# HARTMAN & ASSOCIATES, INC.

**Subject: Request for Additional Information, dated January 10, 2001  
Sid Larkin & Son, Inc.  
Enterprise Recycling and Disposal Facility, Class III Landfill  
Pasco County, Florida  
Pending Permit Numbers 177982-001-SC and 177982-002-SO**

March 20, 2001

**FIGURE 3-14**

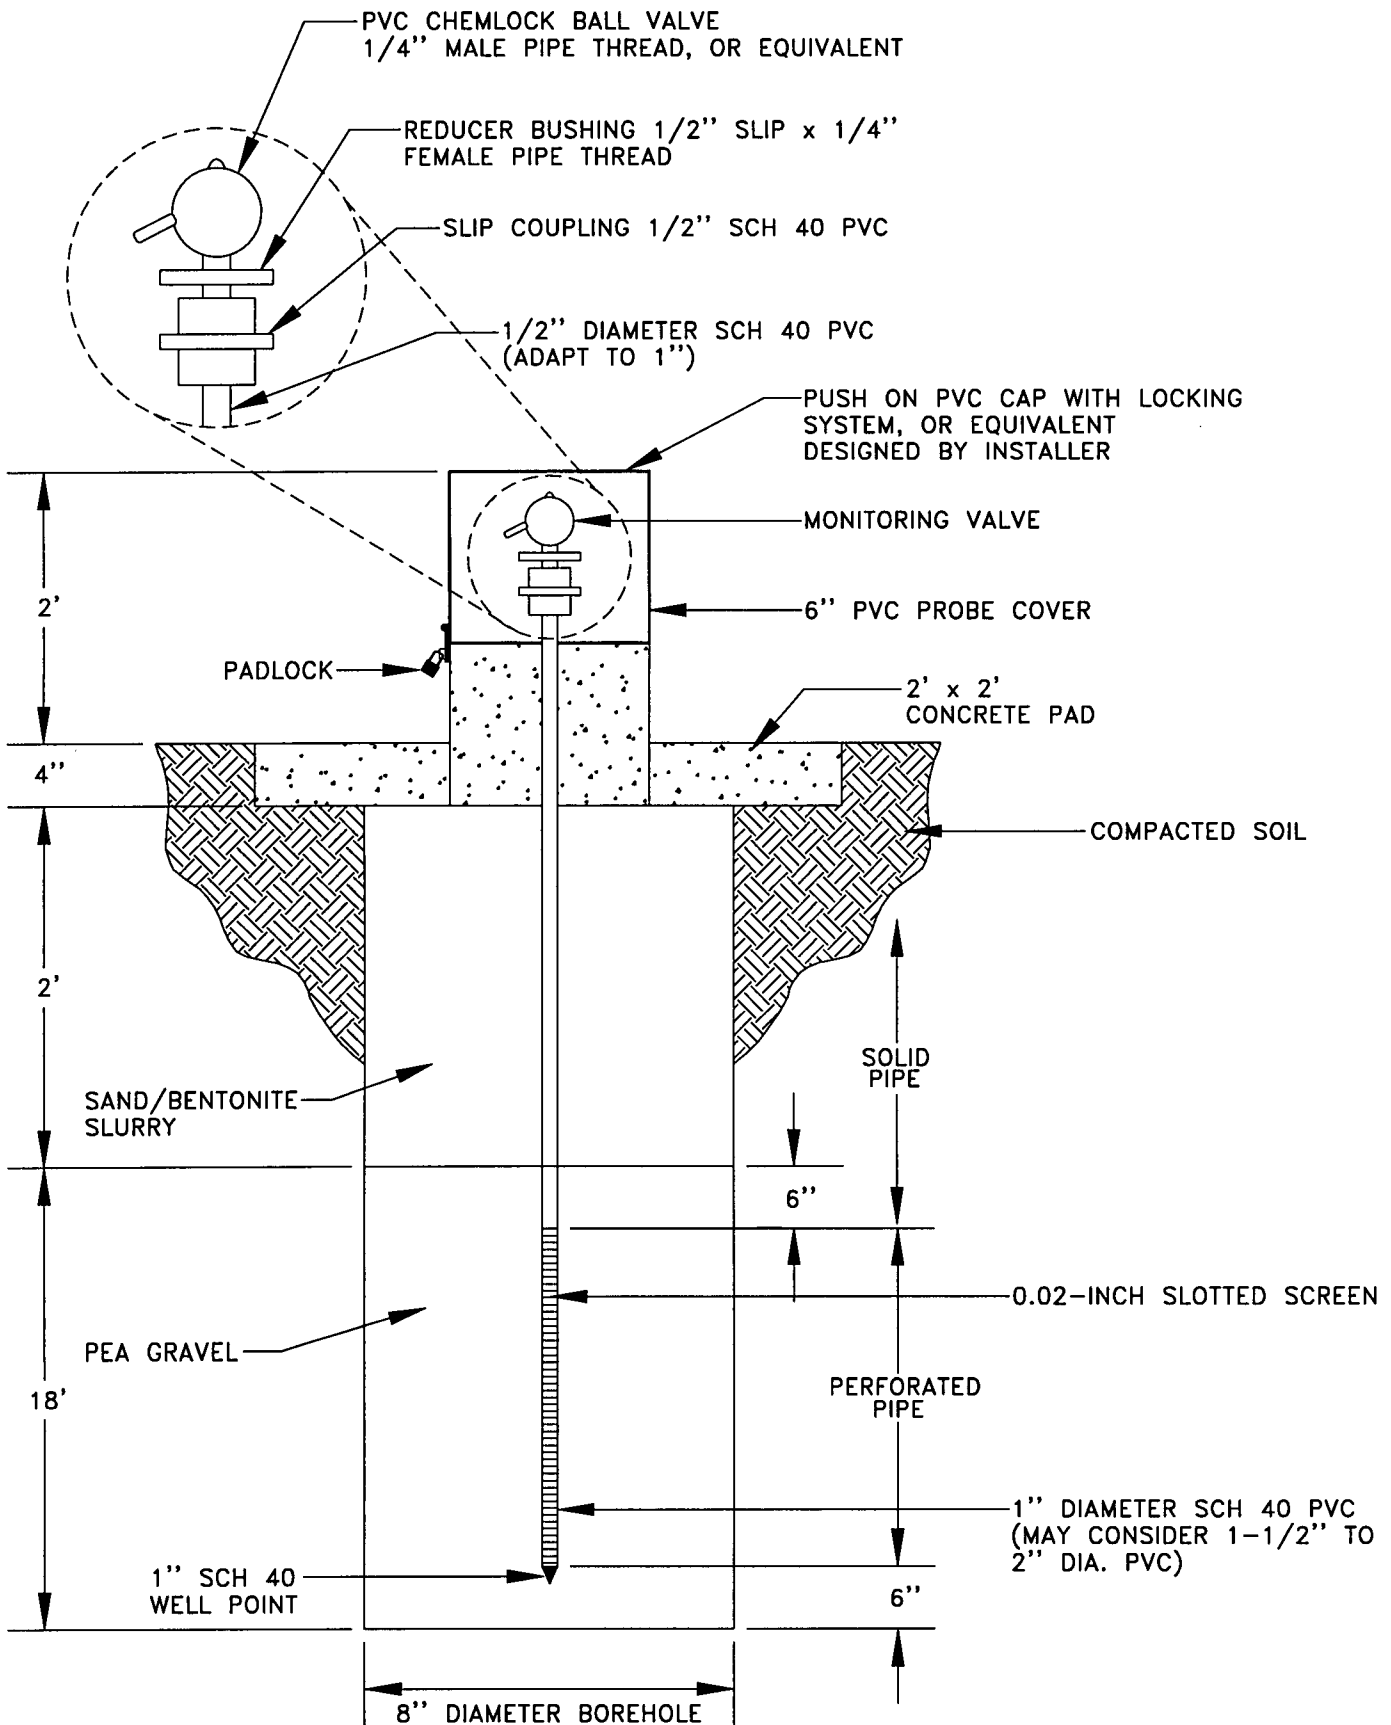
Comment 6. 62-701.400(10). The gas probe detail Figure 3-14 should be revised for at least 6" of separation between the bentonite and screen, and for clarification of slot size for screen.

**Response:** Please see the revised Figure 3-14.

FIGURE  
3-24

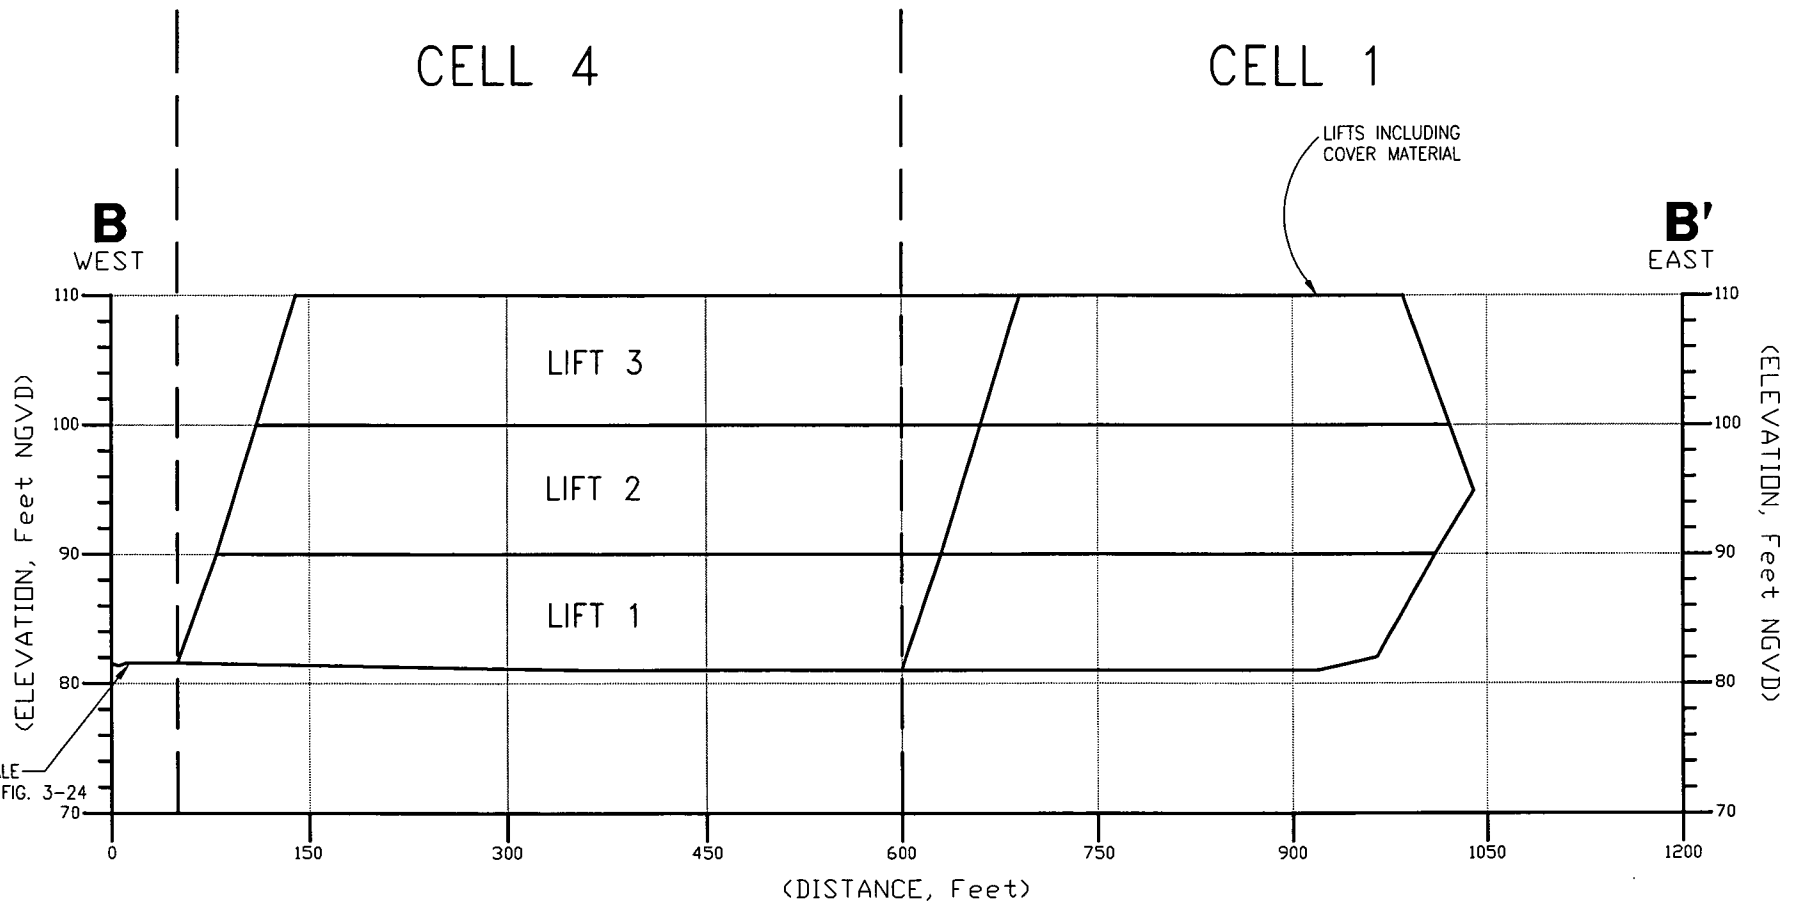
Comment 3. 62-701.320(7)(f)5, and 62-701.330(4)(c) and (d). Site plans including boundary survey (to match legal descriptions), locations of wells and soil borings, grades to drain disposal areas, cross-sections of lifts, fencing, details of equipment, fueling and lubricant storage facilities. Cross-sections are requested north-south and east-west through each cell showing all lifts.

**Response:** Please see revised Site Plan, Figure 3-6 and the cross sections, Figures 3-24, 3-25, 3-26, and 3-27, of sequences 1 and 2, including lifts.

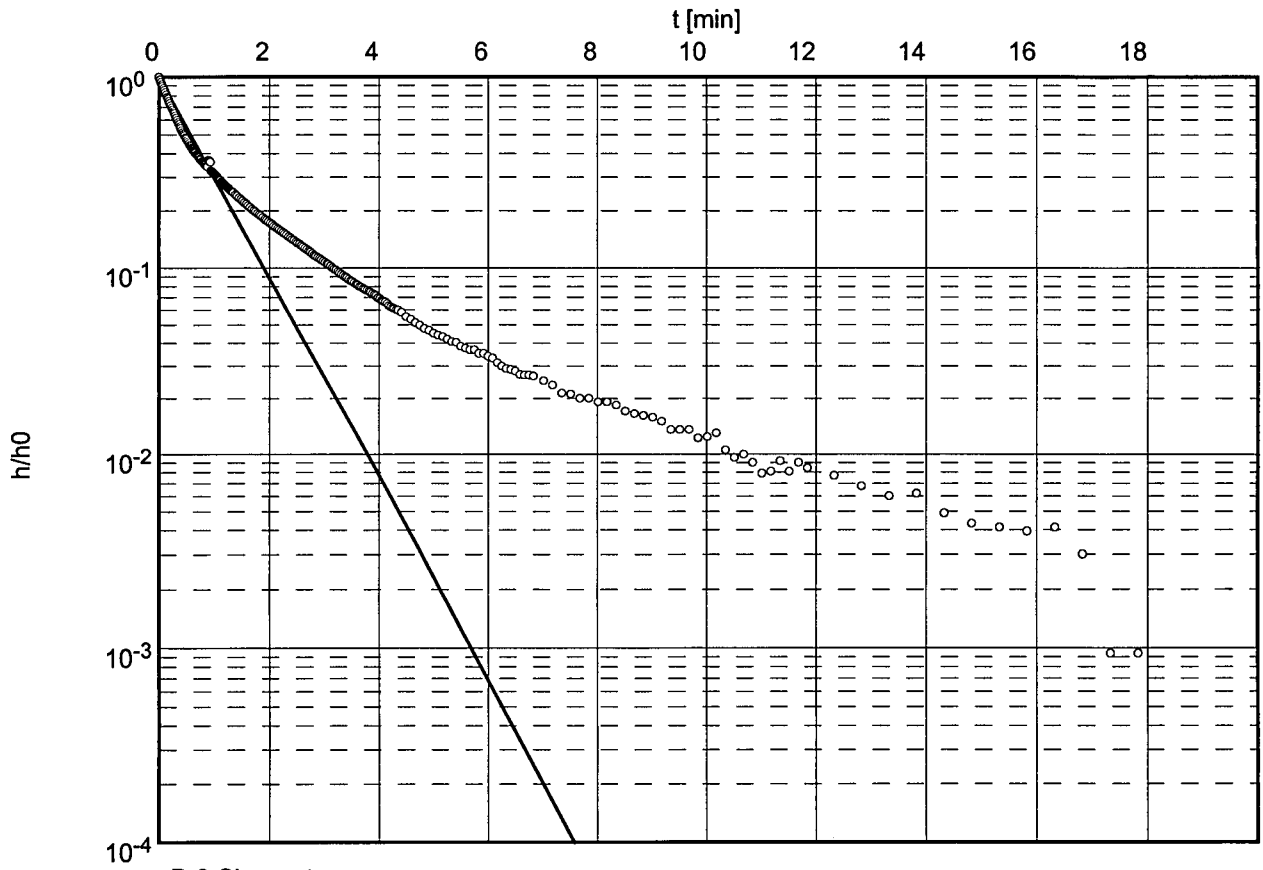
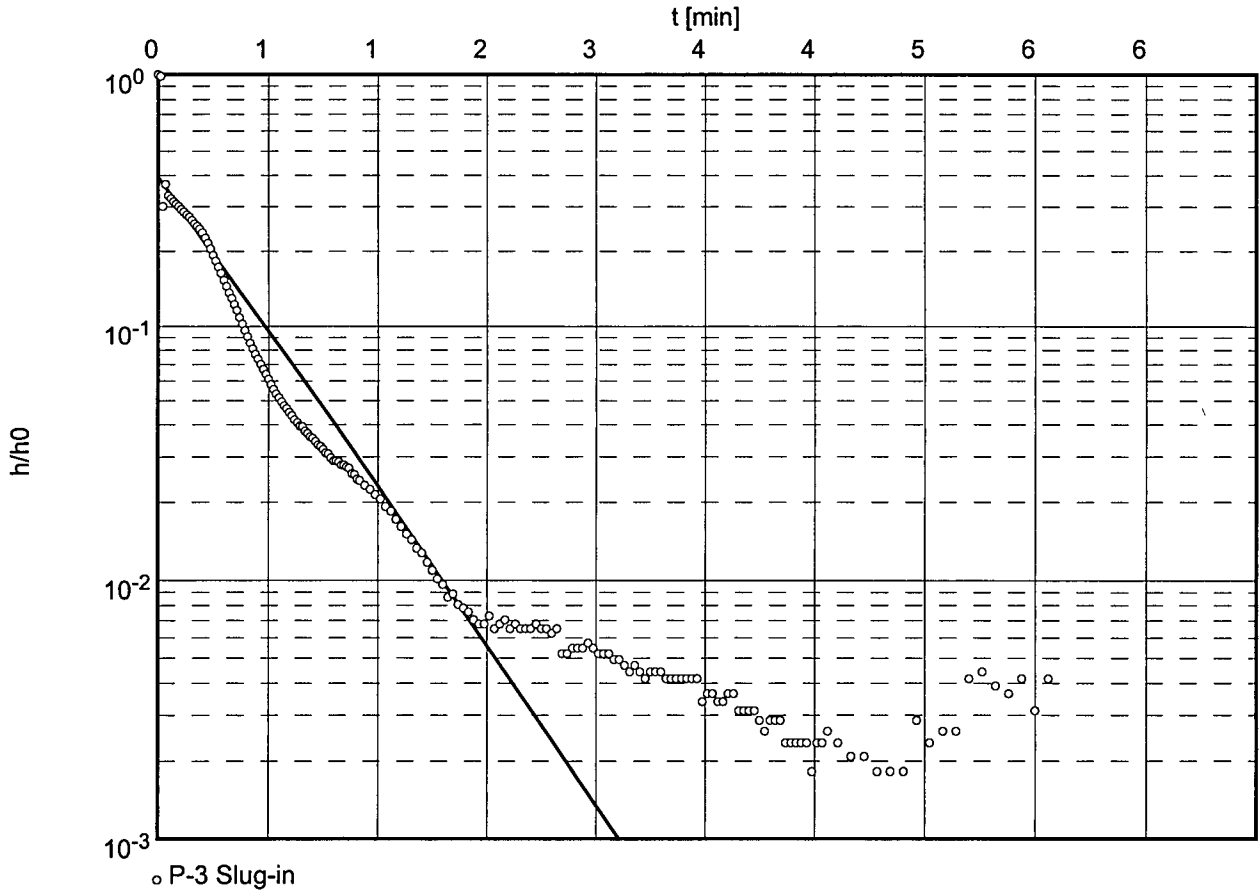
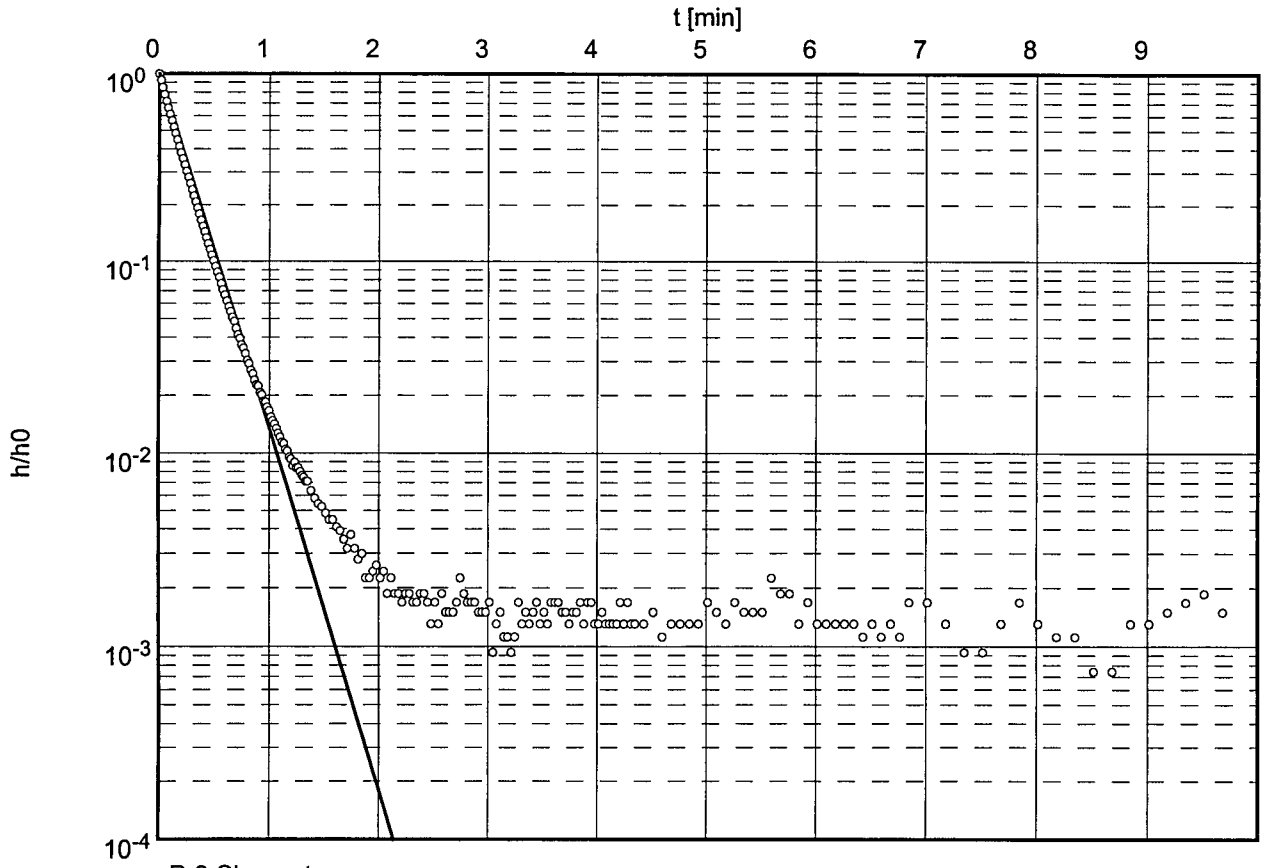
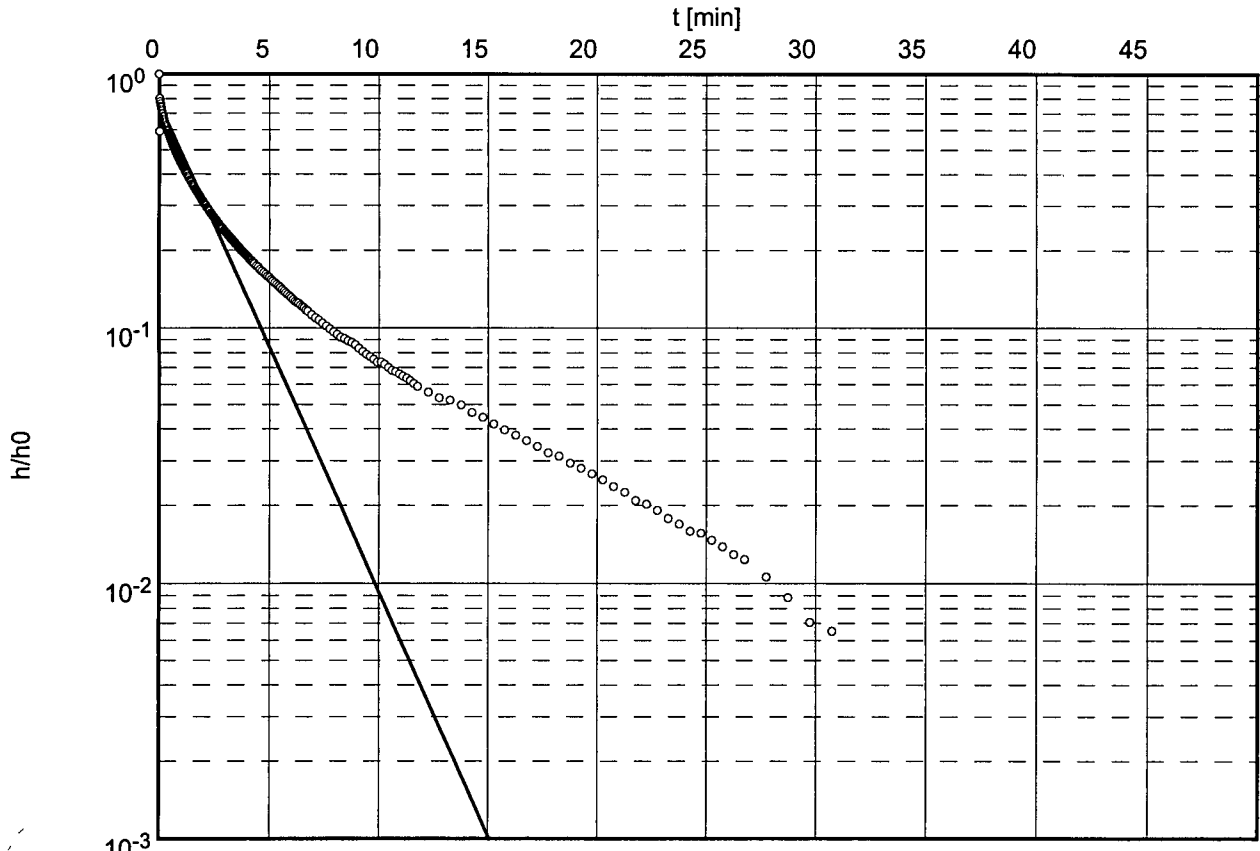
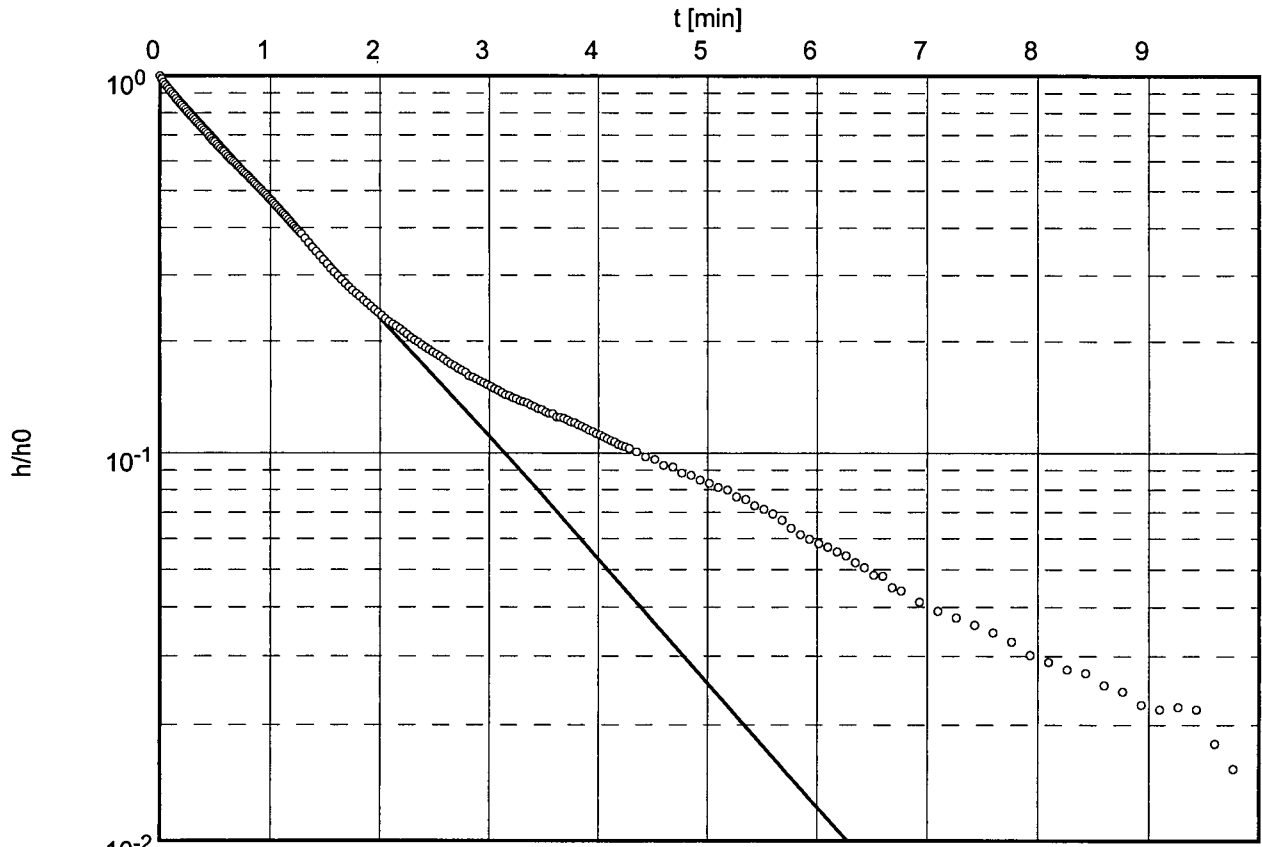
- d. The straight line solutions provided for several of the slug tests included in appendix 5-C of the Hydrogeological Investigation do not appear to correlate with early time data for residual head values. Please indicate why the solutions provided for the tests run at the following piezometers are considered to be valid: P-2 – slug out; P-3 – slug in, slug out; P-3a – slug in; P-7 – slug in, slug out.

**Response:** The original match lines were fitted to the entire data set. To provide solutions based on early time data the match lines were modified for tests in P-2 (slug out), P-3 (slug in and slug out), P-3a (slug in), and P-7 (slug out). The modified graphs and solutions are attached. The match line for P-7 (slug in) was not modified because the initial water table drop, within the first few seconds of the test, is most likely the result of water infiltrated the unsaturated sand pack and not representative of the actual soil hydraulic conductivity.
